**Quanta Computer Inc.**  
**PROJECT : NL-6**

Size	Document Number	Rev
	<b>Google Debug</b>	1A
Date:	Friday, February 21, 2014	Sheet 18 of 40

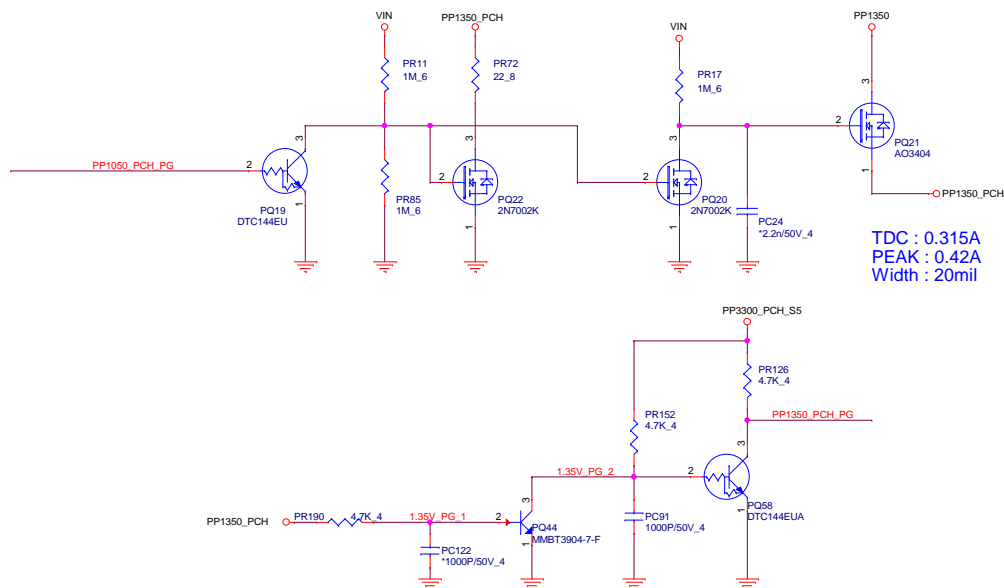
1129 PP1000\_PCH\_S5 change from LDO to switching power

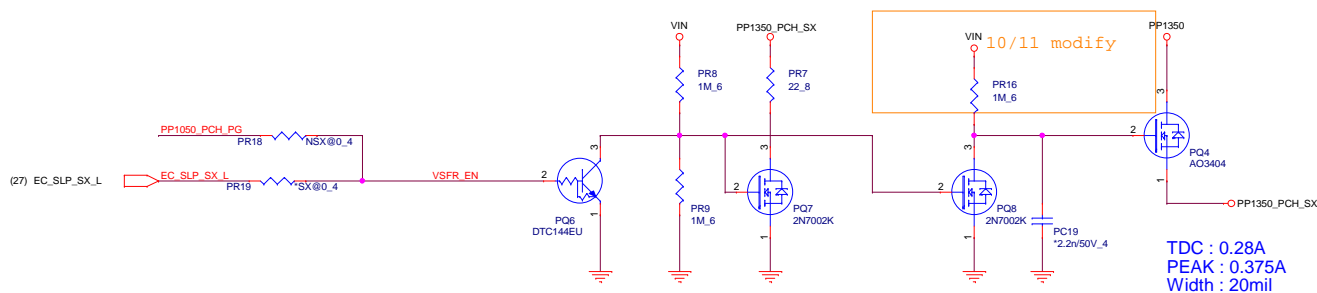
1129 PP1350\_PCH change from LDO to power MOSFET
